Diablo Canyon Power Plant (DCPP) Units 1 and 2  
Response to Second Round Request for Additional Information  
Generic Letter 2004-02, "Potential Impact of Debris Blockage on Emergency  
Recirculation During Design Basis Accidents at Pressurized Water Reactors"

Note: For the licensee's reference, the staff has linked the below issues to question numbers in the staff's RAI package for Diablo Canyon dated August 1, 2008 (ML082050608).

Figure 7-1 Front Sector Test Article Mounted in Test flume with Agitators

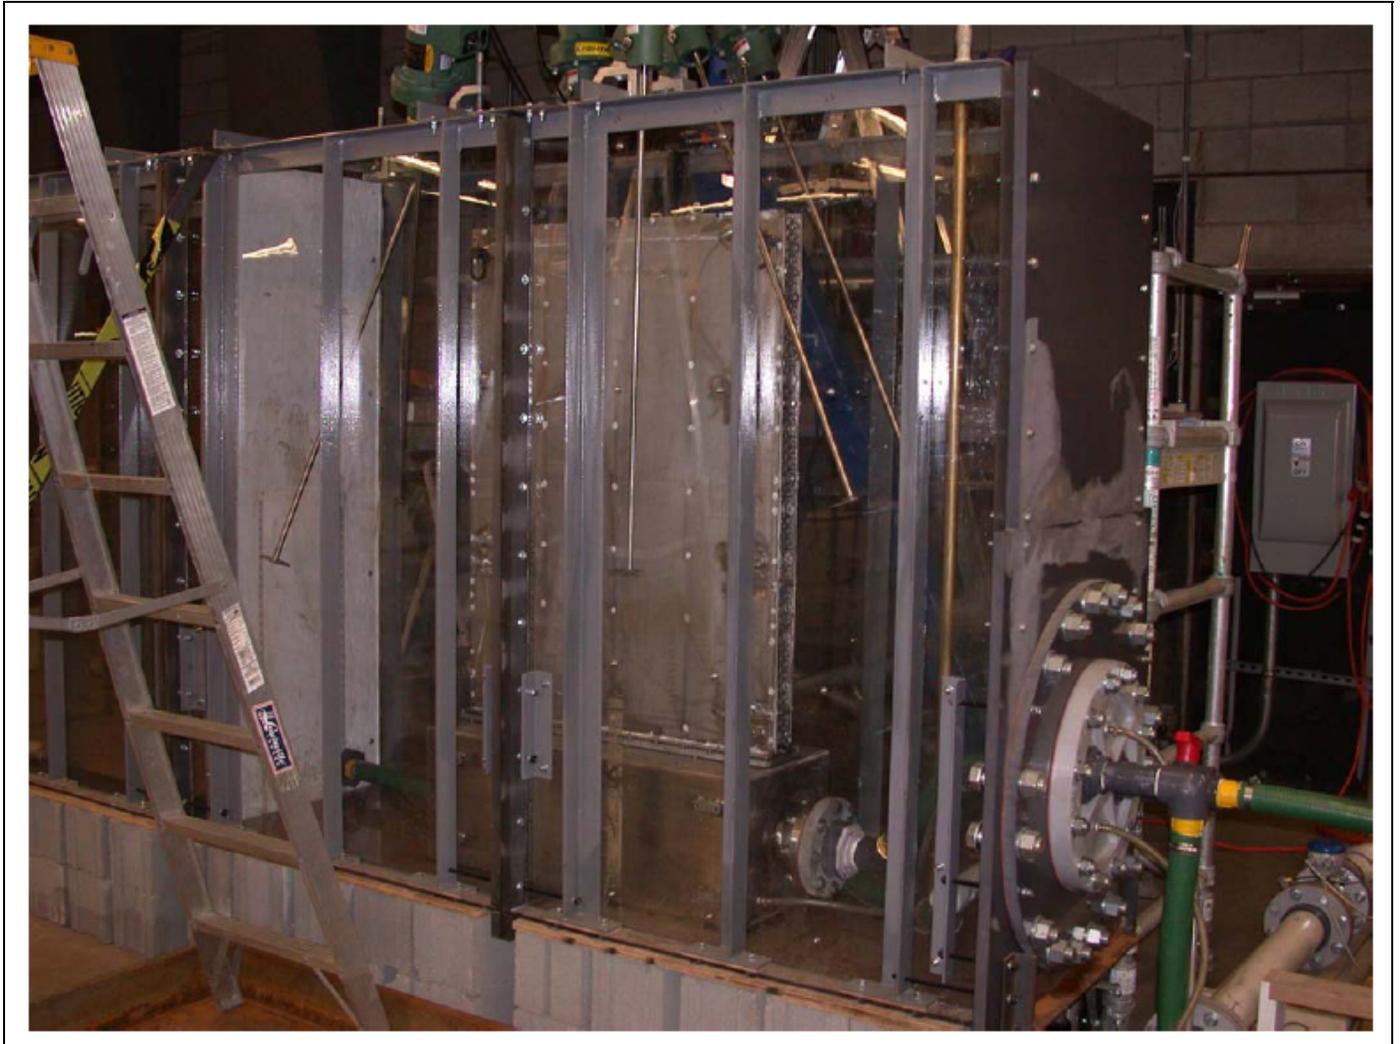
*The staff requested additional information regarding how stirring affected the results of the head loss test. The licensee provided information that justified that excessive debris settlement did not occur. However, it is also possible that the stirring affected the debris bed non-prototypically such that debris did not accumulate uniformly over the strainer surface as would occur if added turbulence was not present. Post-test photographs and inspection of the strainer showed that an unexpected non-uniform distribution of debris on the strainer occurred. It was particularly unusual that photographs showed less debris accumulation near the bottom of the strainer than elsewhere. Additionally, the test resulted in a significantly increased deposition of paint chips on the strainer compared to what would be expected in the plant. The licensee should provide information that justifies that the debris bed formed during testing is a realistic or conservative representation of what would occur in the plant.*

The DCCP design basis debris testing program was performed using a sector of the front strainer. [Figure 7-1] This front strainer test sector produced the worst case head loss of any of the strainer test articles. Recall that the rear strainer module test article with a plenum on the bottom produced significantly less head loss with equivalent debris load. Additionally, recall that the rear strainer module test article produced less head loss than did a rear strainer test sector with equivalent debris load. The test article that produced the worst case head loss was the front strainer sector. [Ref 7-2, Page 68]

With a front strainer sector test article, the entire outside surface is solid stainless steel plate. The test flume has six agitators to ensure a homogeneous mixture of debris. There are two agitators vertically down, one on each side of the plenum. There are four agitators installed next to the outside solid stainless steel surface and are crossed at an angle of approximately 60 degrees down. The propellers on these 4 agitators are approximately 6-inches from the floor. Note by comparison the screen is only 1-inch above the floor. Thus the strainer gap is completely protected from the direct flow of any agitator. Each agitator has a variable-speed motor and is set to develop a relatively gentle eddy current with no preferential direction of the debris material. This arrangement ensures that there is no disruption of debris at the edges of the strainer and no debris "wash-away."

FIGURE 12-1 Water Levels Used in NPSH Analysis

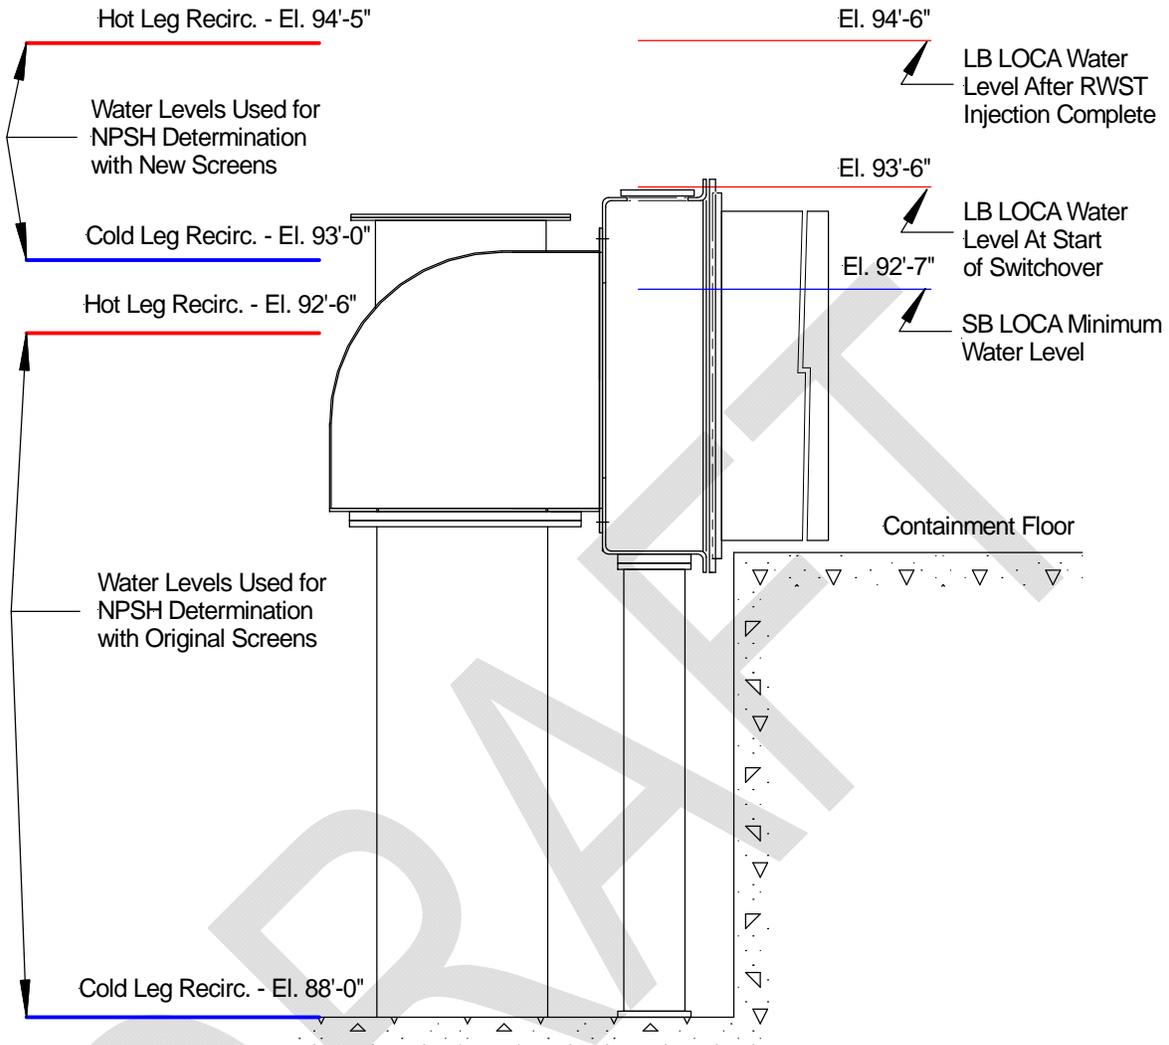
*The staff requested that the licensee provide a revised table showing the results of the net positive suction head margin calculation without including the head loss from accumulated debris. The table provided by the licensee on page 29 of the November 3, 2008, supplemental response showed the individual contributions from the increased containment water level assumed by the licensee, as well as the impact of the strainer and debris bed head losses. The licensee indicated that the previous net positive suction head calculations conservatively did not take credit for minimum sump water levels. The staff questions this response because a 5-ft level increase was credited for cold-leg recirculation, whereas only a 2-ft level increase was credited for hot-leg recirculation. The staff expected that the minimum water level available for hot-leg recirculation would be greater than or equal to the minimum cold-leg recirculation water level. Furthermore, the licensee's response, dated July 10, 2008, indicates that the minimum pool depth is 1.8 ft for a small-break LOCA and 2.6 ft for a large-break LOCA. Even at the point when the containment spray pumps are secured, this supplemental response states that the calculated minimum pool level could be a minimum of 3.5 ft. Therefore, the basis for crediting a 5 ft increase in water level for the cold-leg recirculation case to account for the minimum containment water level was not clear to the staff, since it appeared that a minimum level of 5 ft could not be assured post-LOCA. In light of the discussion above, please provide a technical basis to demonstrate that the increased water levels credited for cold-leg and hot-leg recirculation are justified in light of the minimum containment water levels for Diablo Canyon, or provide a different level with justification.*

The changes in water level reflect differences in the assumptions used in the analyses. Figure 12-1 illustrates the physical changes credited in both the cold-leg and hot-leg recirculation NPSH analyses.

The Diablo Canyon containment floor is at elevation 91'-0". The containment sump floor elevation is at 88'-0", three feet below the containment floor. This difference in elevation is the reason there is a five foot level difference in the cold-leg recirculation NPSH analysis and only a two foot difference in the water level assumed in the hot-leg recirculation NPSH analysis.
